Architect's Supplemental Instructions

Architect's ASI No: 009

Project:
Webster University
Interdisciplinary Science
Building

Date Issued: 08/01/2016

A0703.B

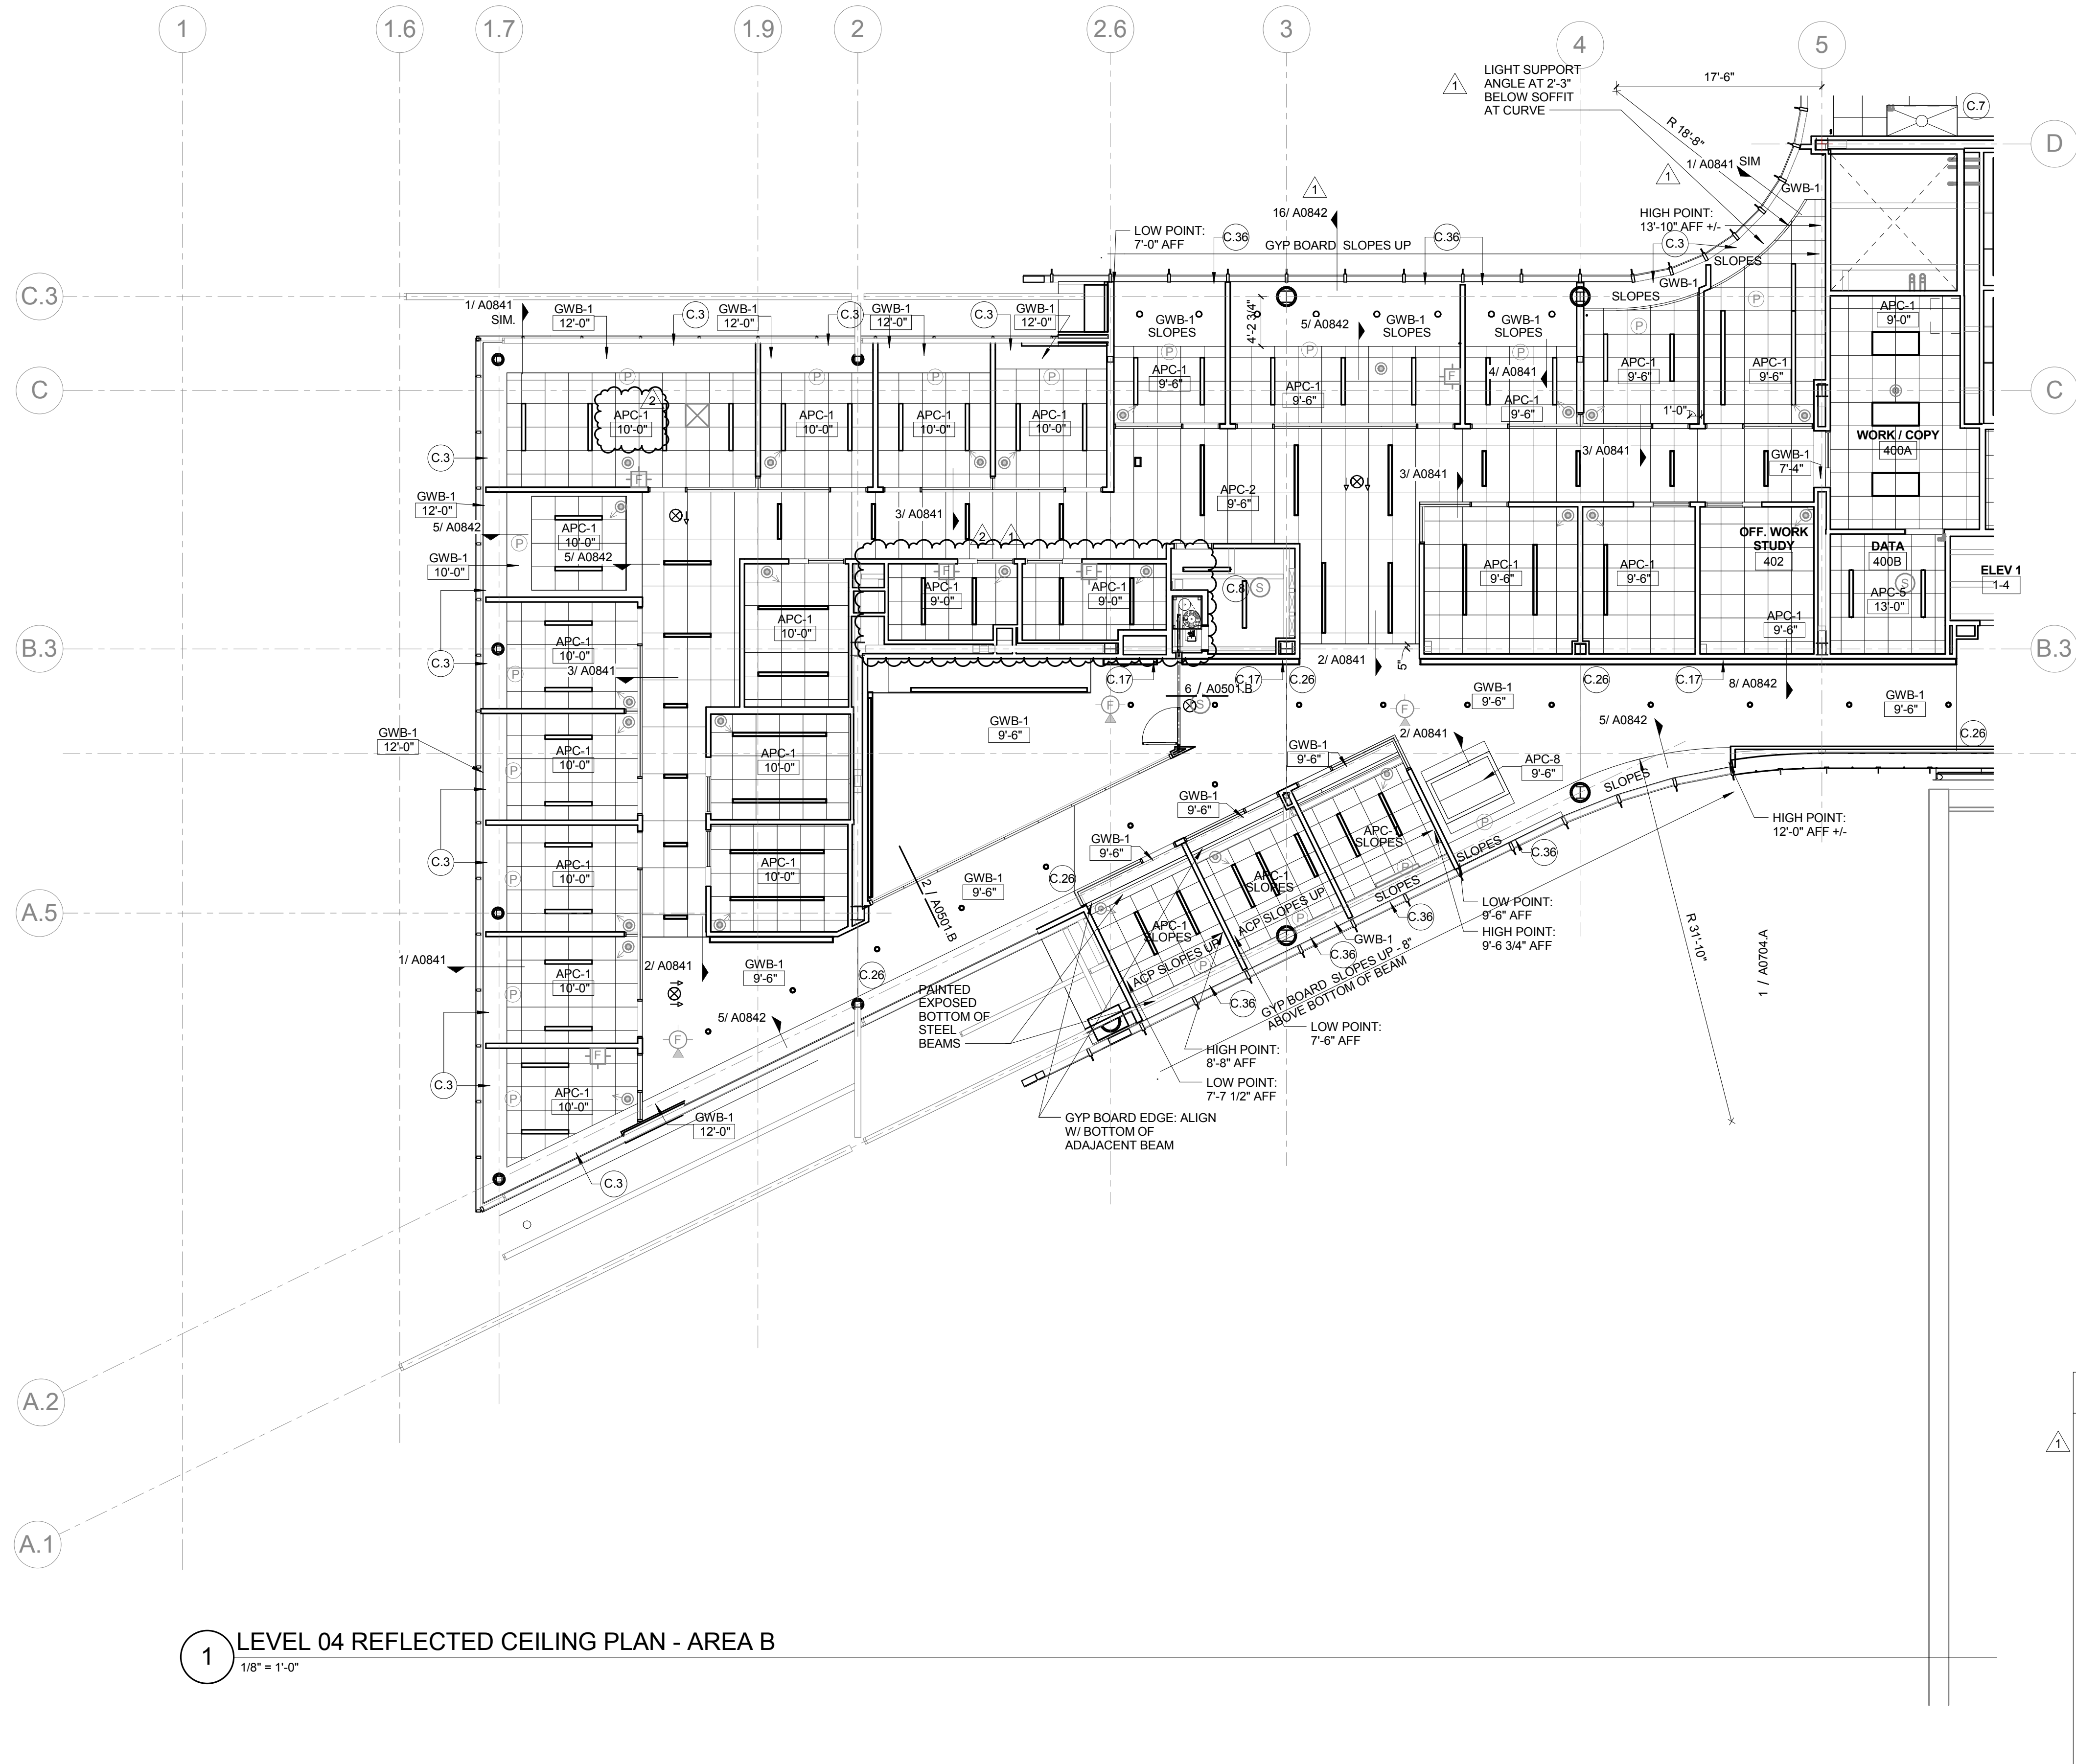
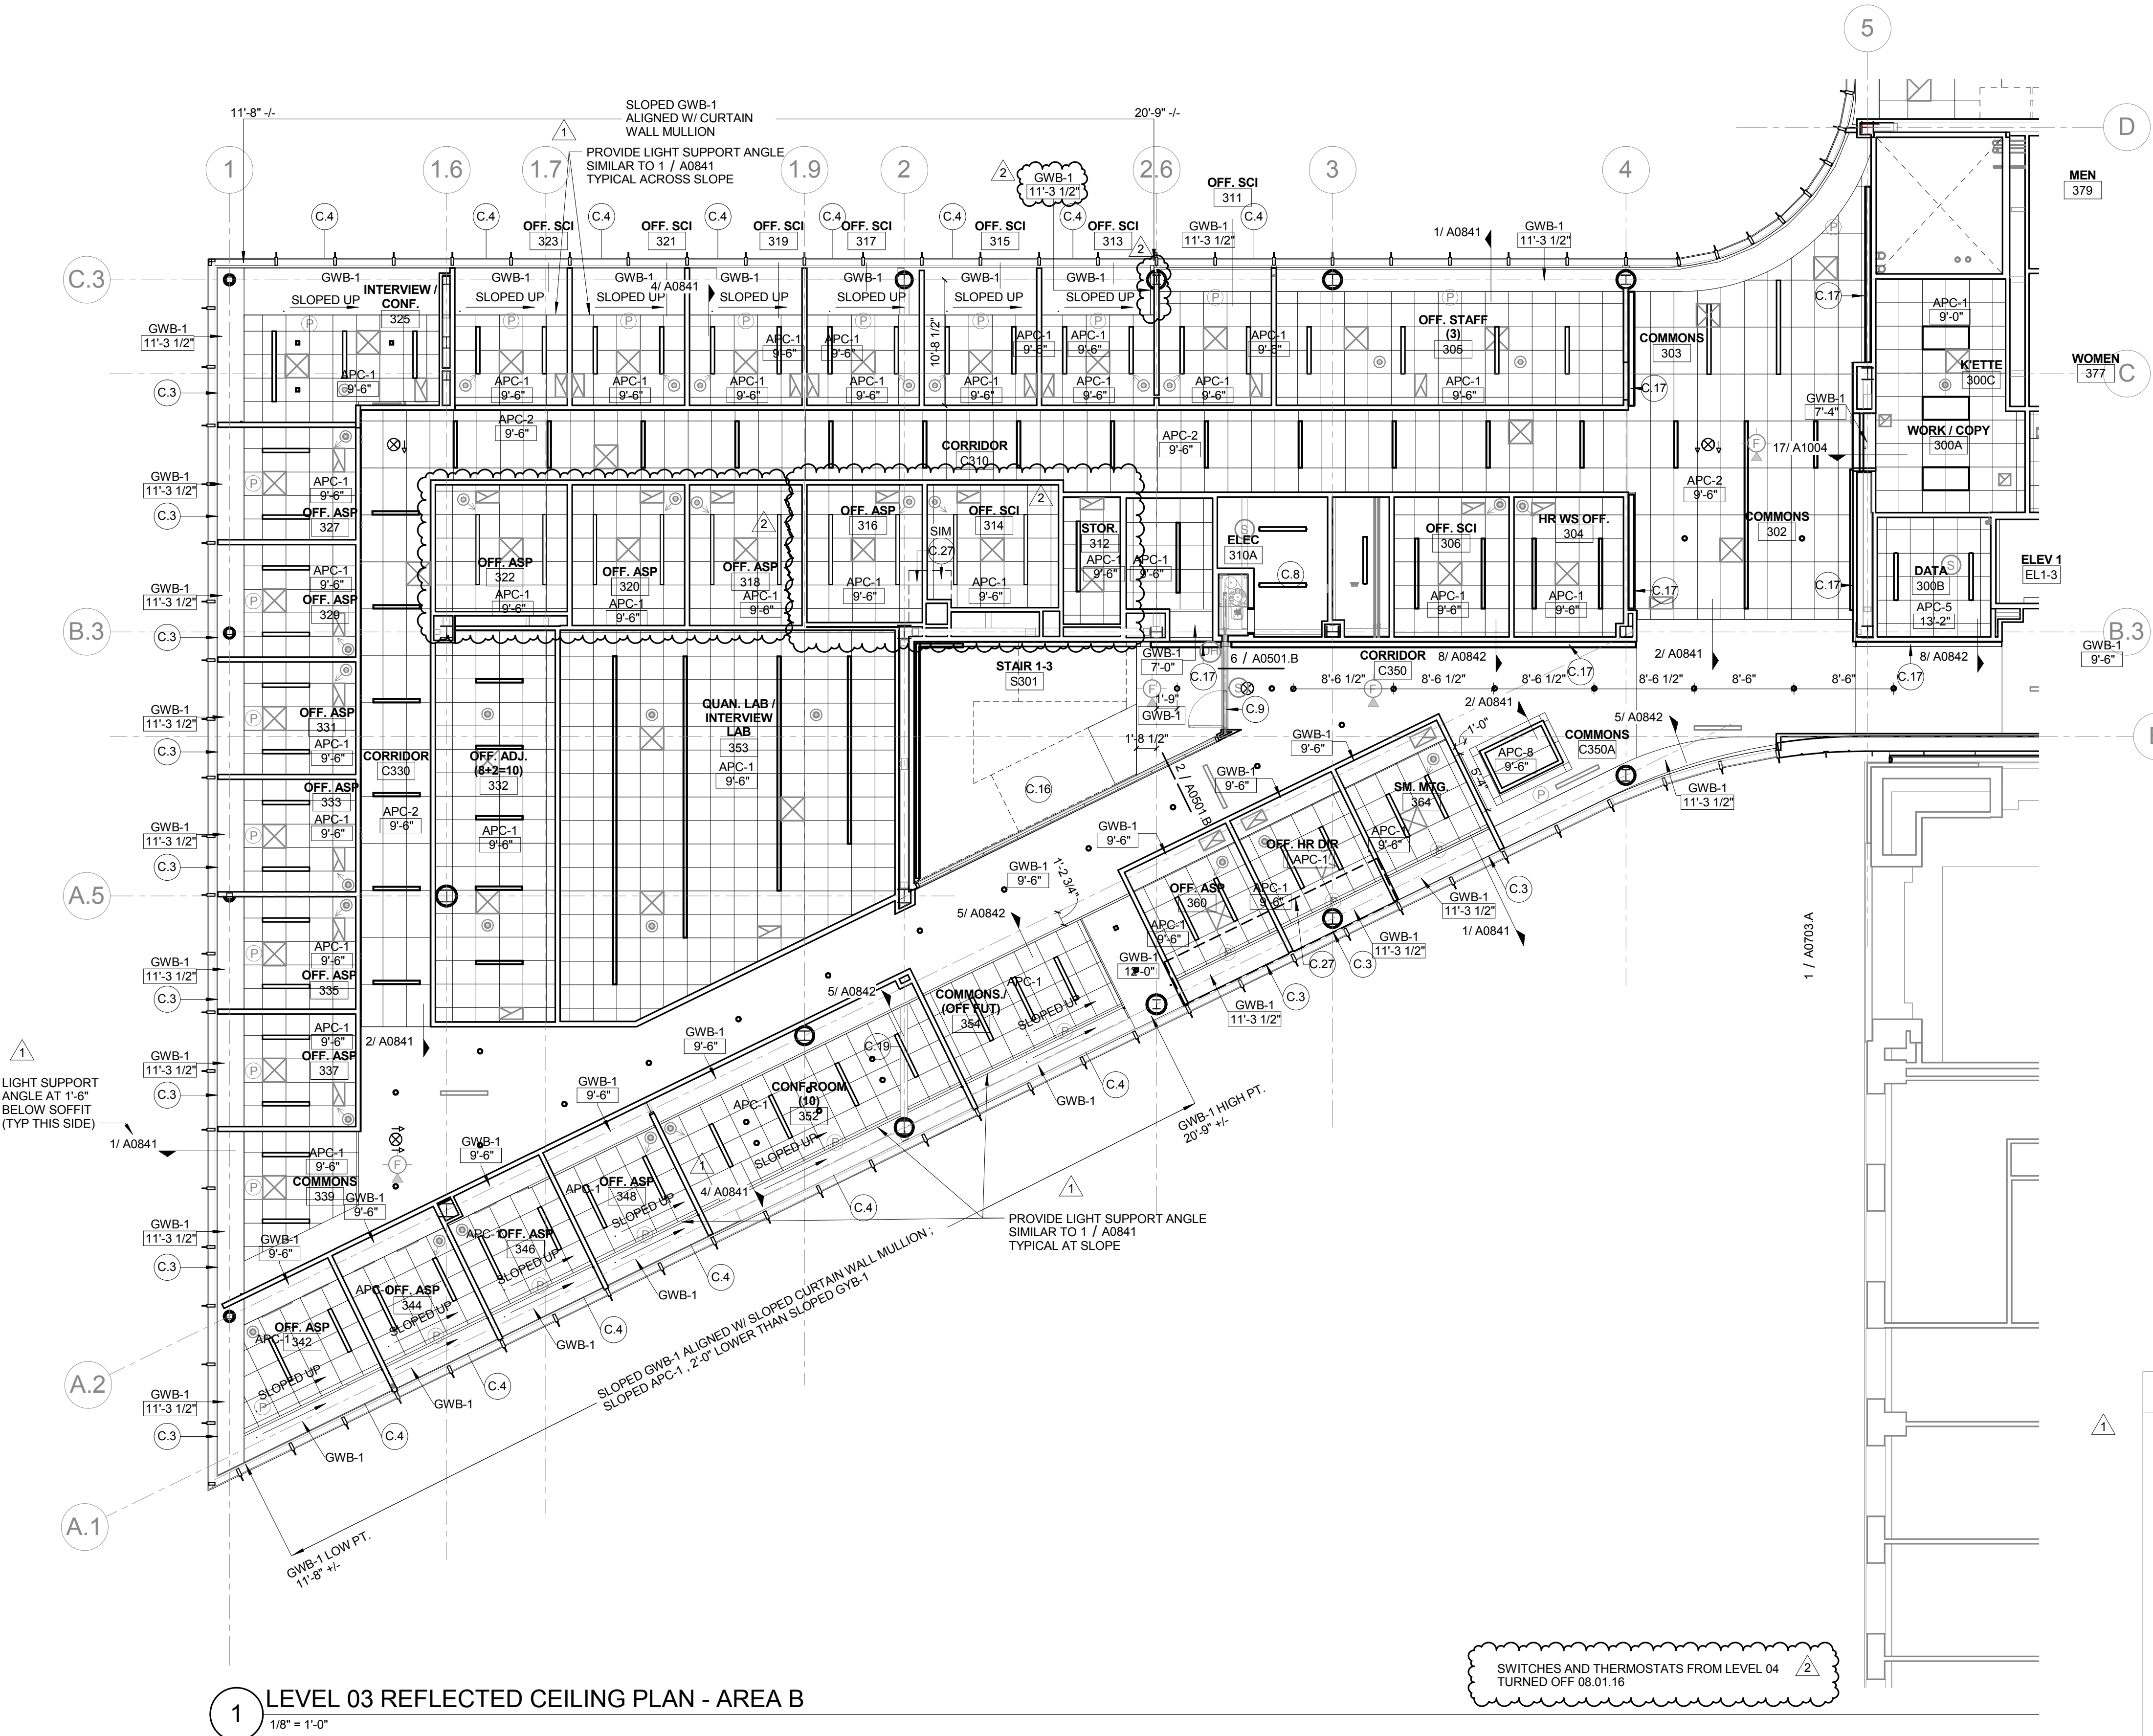
5. On A0703.B changes include clean-up of drawing appearance to
 1. Show light locations in rooms 314, 316, 318, 320 and 322. (Lights shown on electrical drawings did not show up in these rooms)

2. Hide switches and thermostats from level 04 showing up previously on this ceiling plan.

SWITCHES AND THERMOSTATS FROM LEVEL 04
TURNED OFF 08.01.16

M0102.B

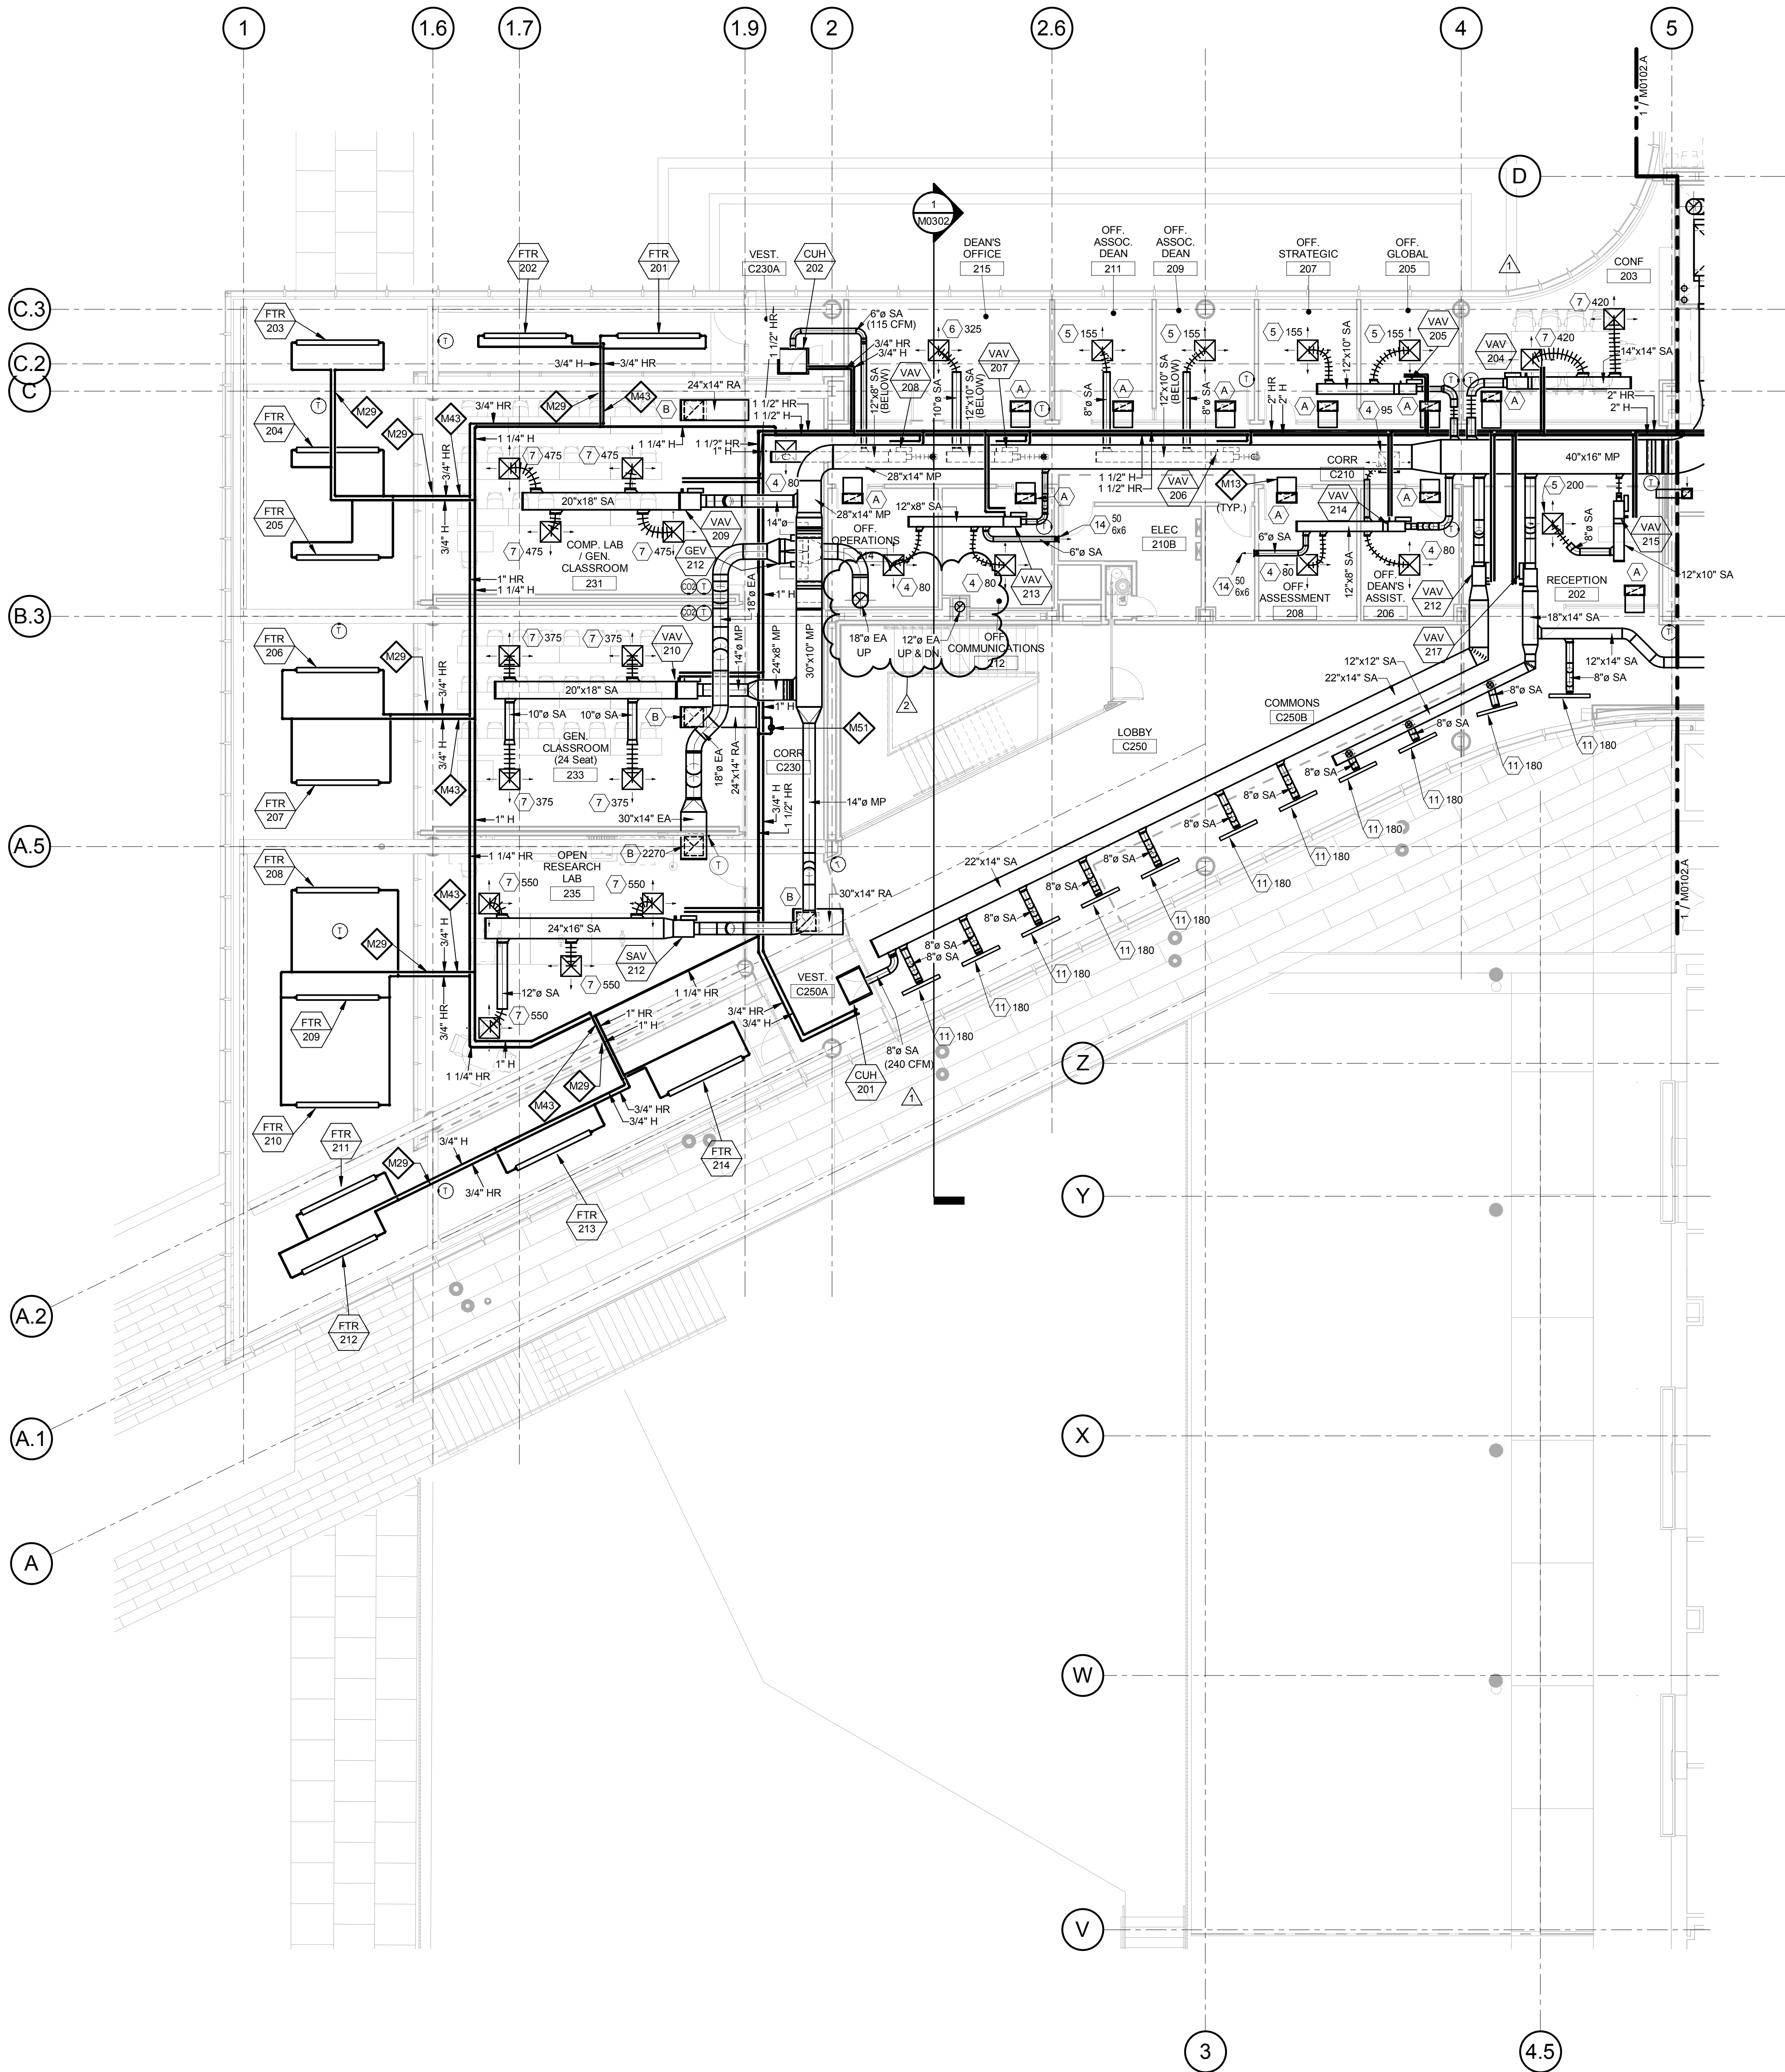
4. Mechanical Drawings: Modify location of exhaust riser from L01 and L02 near columns B.3 / 2 to coordinate with revised chase locations on the architectural drawings.
